Staff
Summary
Report

SUBJECT: SALT RIVER PROJECT CREDIT UNION #SPD-99.16

BRIEF: This is the first public hearing for Salt River Project Credit Union for an Amended Preliminary Planned Area Development for Papago Park Center and a Final Planned Area Development for Parcel F-1 at 1511 North Project Drive.

CONCEPTUAL PARTIAL SITE PLAN AND ELEVATIONS

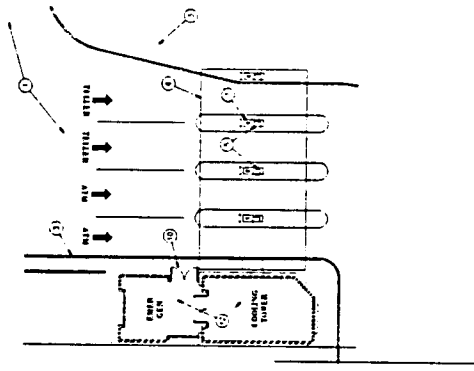
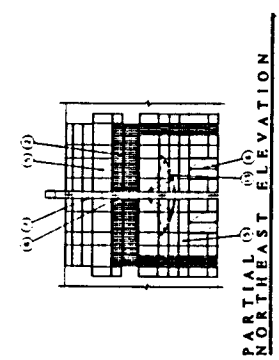
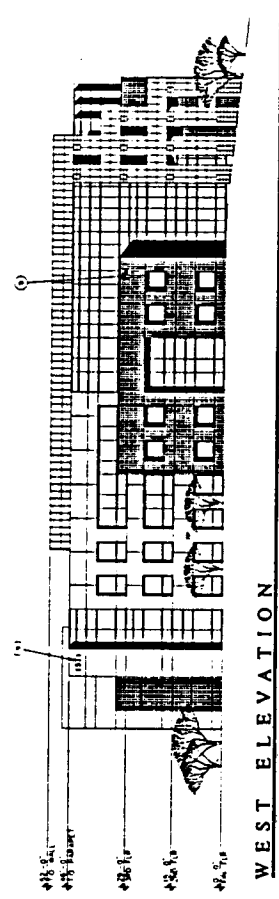
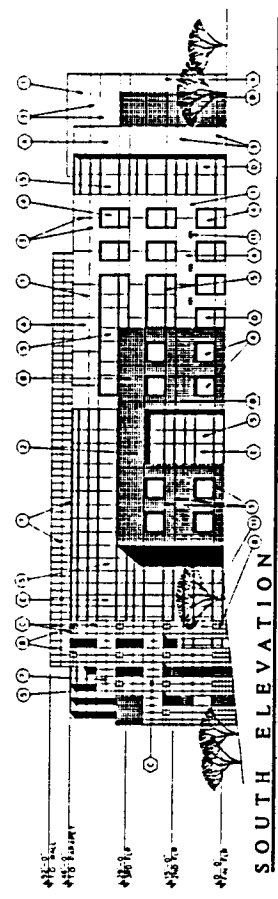
14. Credit Union Building: Provide an additional ½" deep x 2" high reveal on the top portion of all the forty-six (46) foot high concrete panels. The reveal shall line up with the proposed four (4) inch fins located on the adjacent, recessed, glass curtain wall. Details to be approved by staff.

15. Drive Thru Tellers/ATMs: Enclose the video tellers/ATMs with concrete or masonry pilasters to provide column bases for the metal roof canopy. Materials/colors to match the Credit Union Building. Details to be approved by staff.

22. Address number shall be of contrasting colors, with illuminated source from dusk to dawn and not obstructed by landscape or other conflicts. Address numbers must be shown on all building elevations or as determined by the Planning and CPTED staff.

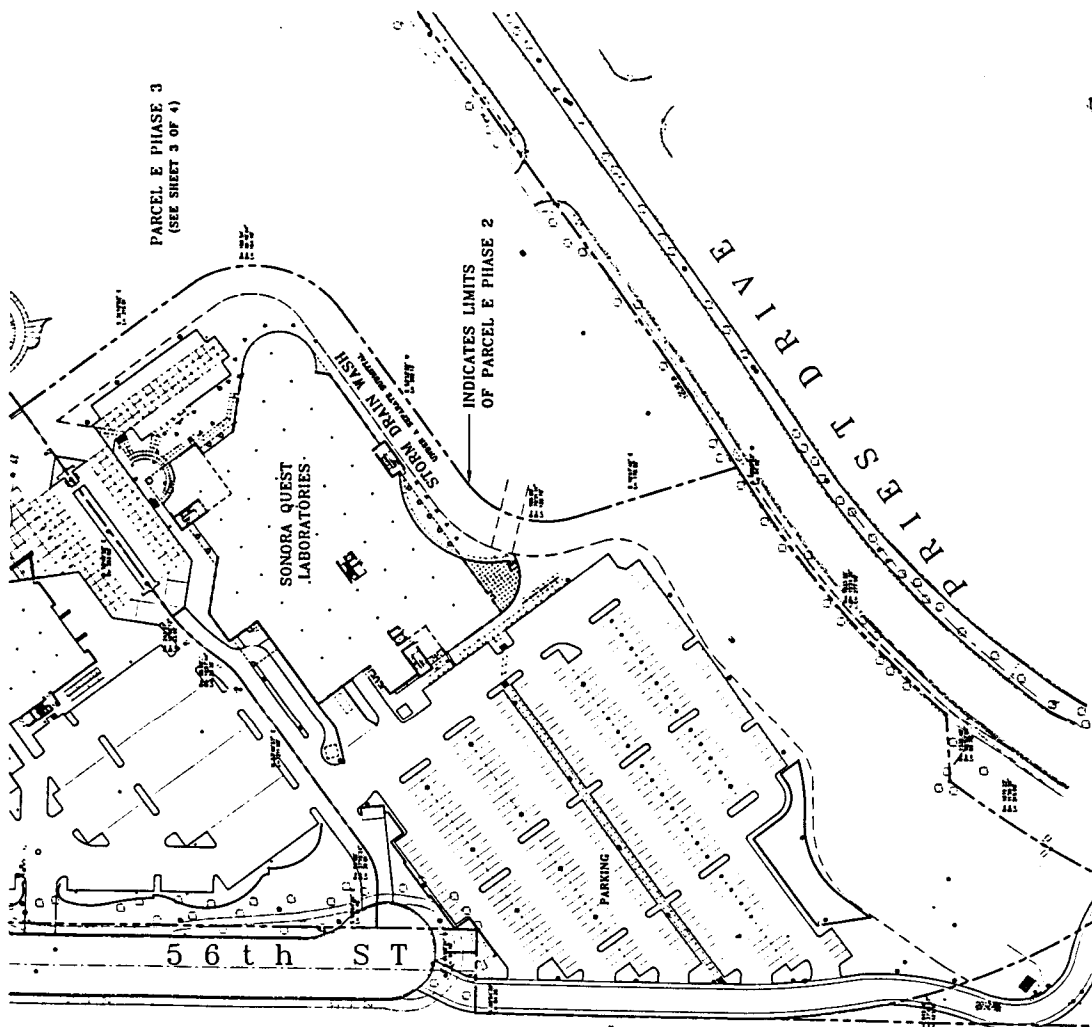
4. Provide upgraded paving materials, such as unit pavers, exposed aggregate, or colored concrete, as accents for all pedestrian sidewalks on the site, for a crosswalk across the parking area to the building, at the main entry to the building, and at all the main drives to the site.

11. Since the gross floor area for this development exceeds 50,000 g.s.f., then the development must meet the Ordinance requirement for art-in-private-development. If artwork is to be provided on-site, show the location on the site plan.

23. Show the location of all exterior light fixtures on the landscape plan.
24. Show traffic sight triangles at all driveways. Any landscaping within these sight triangles must be selected from the Traffic Sight Triangle Plant List, which may be obtained from the Development Services Department.
